# Wisconsin Department of Transportation

**Proposal #15: 2718-15-70, WISC 2020 043**  
**Chinook Pass, Town of Waukesha**  
**CTH ES to Les Paul Parkway**  
**STH 164**  
**Walworth County**

This is Addendum No. 02, which provides for the following:

Addendum No. 02  
ID 2718-15-70  
Revised Sheet 18  
February 4, 2020

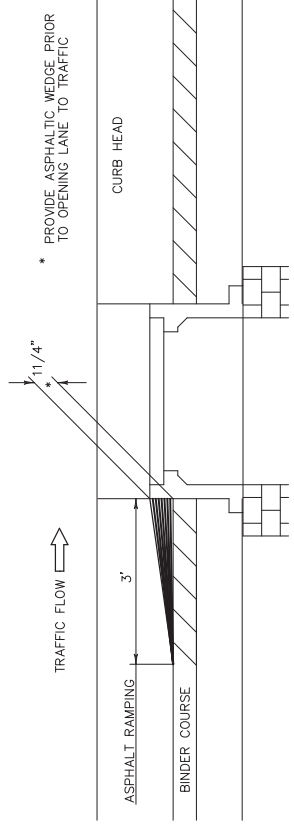
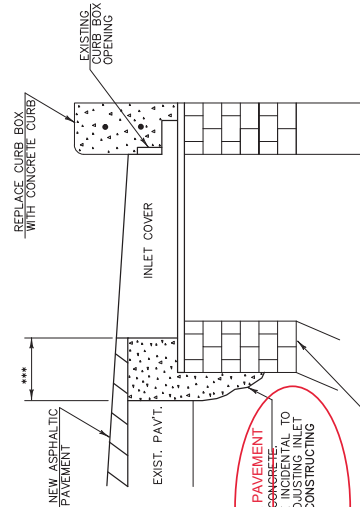
Revised Plan Sheets	
Plan Sheet	Plan Sheet Title (brief description of changes to sheet)
18	Revised
109	Revised MH cover type from A to J
341	Miscellaneous Quantities – added items

7. THE CURB BOX OPENING SHALL BE SEALED BEFORE POURING CONCRETE CURB TO PREVENT CONCRETE FROM ENTERING STRUCTURE.
8. WHEN CURB PLUG IS NOT REQUIRED, REPLACEMENT OF CONCRETE CURB AND GUTTER IS TO BE PAID FOR UNDER "CONCRETE CURB AND GUTTER, ~~9'-10"~~ 9'-10"
